Report to the Future Melbourne (Planning) Committee

Planning Permit Application: TP-2018-429
96-102 Franklin Street, Melbourne

3 December 2019

Figure 5: Excerpt from Survey Plan prepared by Bosco Jonson Pty Ltd (9 February 2019) showing easements in favour of City Power Pty Ltd

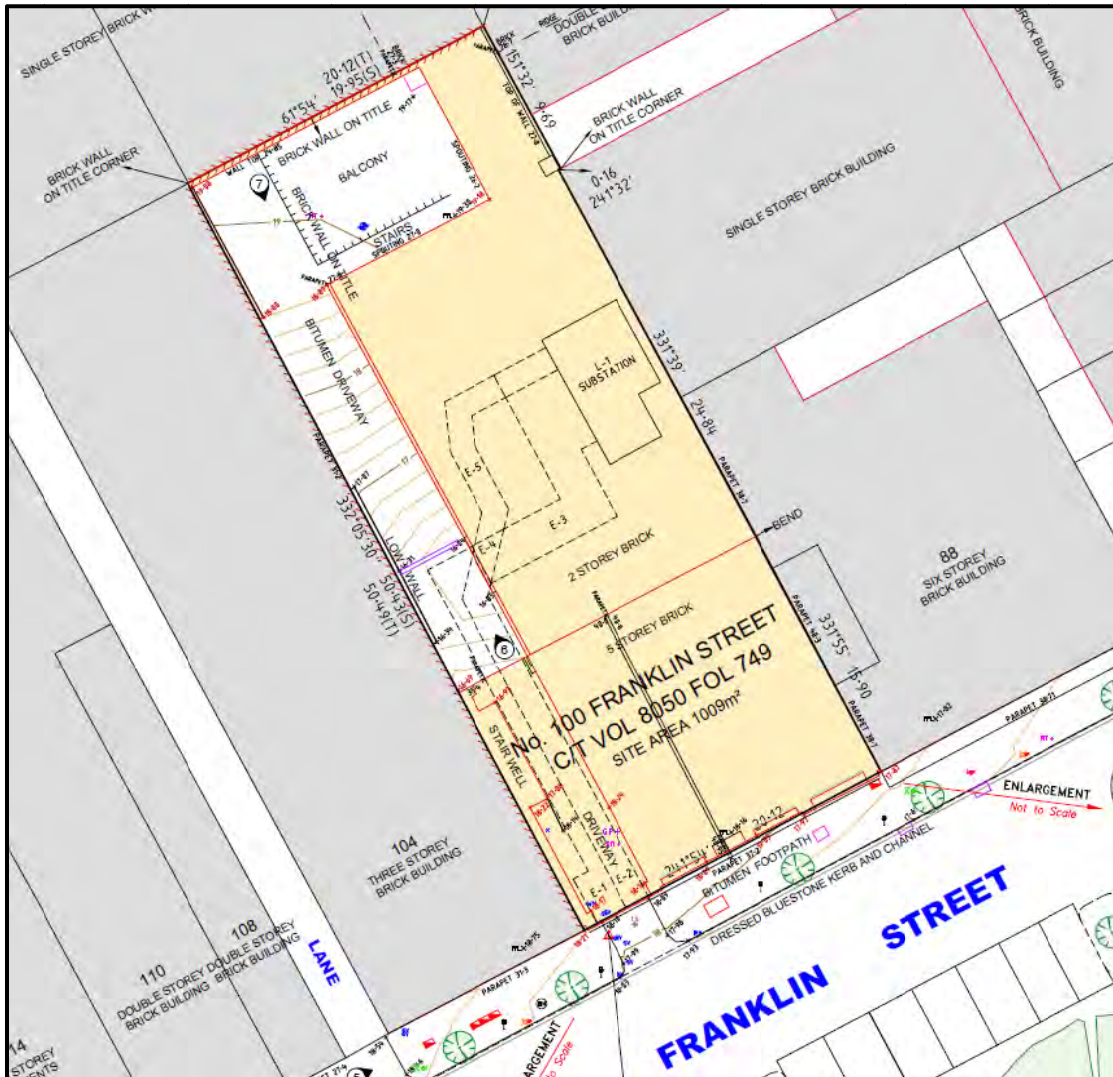
- No restrictive covenants or S.173 Agreements burden this title.
- Whilst Title Plan 695112V submitted with the application does not appear to show any easements encumbering the land, the annexure to Caveat AG357368K registered against the title on 18 February 2009 describes several easements to be created in favour of City Power Pty Ltd.

The Boundary Re-establishment Feature and Level Survey and Site Analysis Plan prepared by Bosco Jonson Pty Ltd (dated 9 February 2016) submitted with the original application details the location of these easements.

As Application TP-2018-429 has not specifically sought planning permission to remove or vary any easements encumbering this land.

A note has been recommended for inclusion on any permit being granted identifying that the planning permit has not authorised the removal or variation of these easements, and that the consent of City Power Pty Ltd must be obtained prior to any works commencing.

Figure 12: Excerpt from Drawing No. TP-010 illustrating design response of tower form

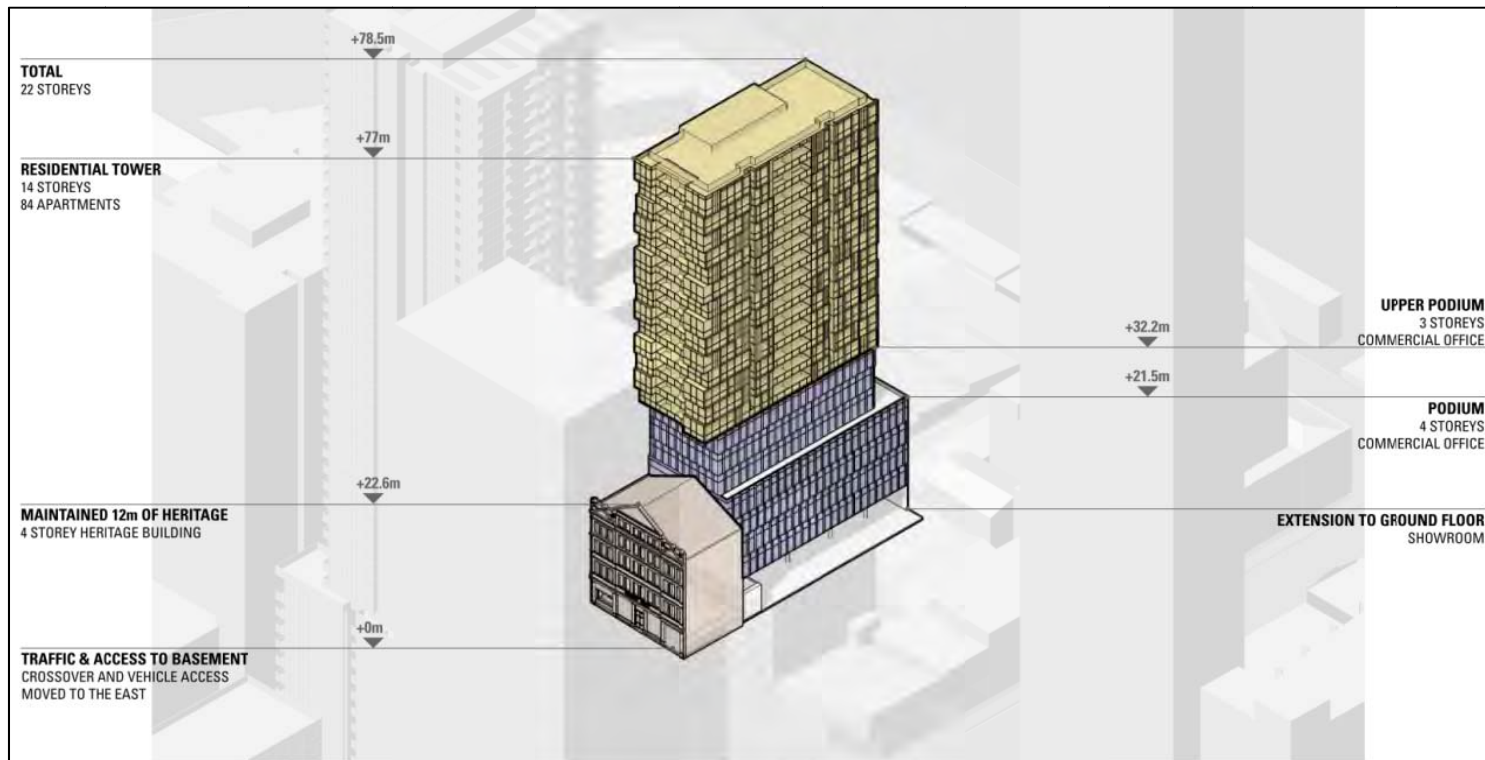
- The development is massed to read as two distinct forms (further reinforced by the architectural and façade detail).
- The heritage asset is provided with breathing space, allowing it to be appreciated as its own intact entity.
- Significant elements of the heritage asset can be meaningfully retained to provide a greater impression of the integrity of the building (i.e. by retaining 12 metres of the roof form).

- The diagram provided below illustrates the massing and modulation of architectural forms that contribute to this outcome, which is considered to be an appropriate heritage response for a 'B' graded heritage asset of this calibre.
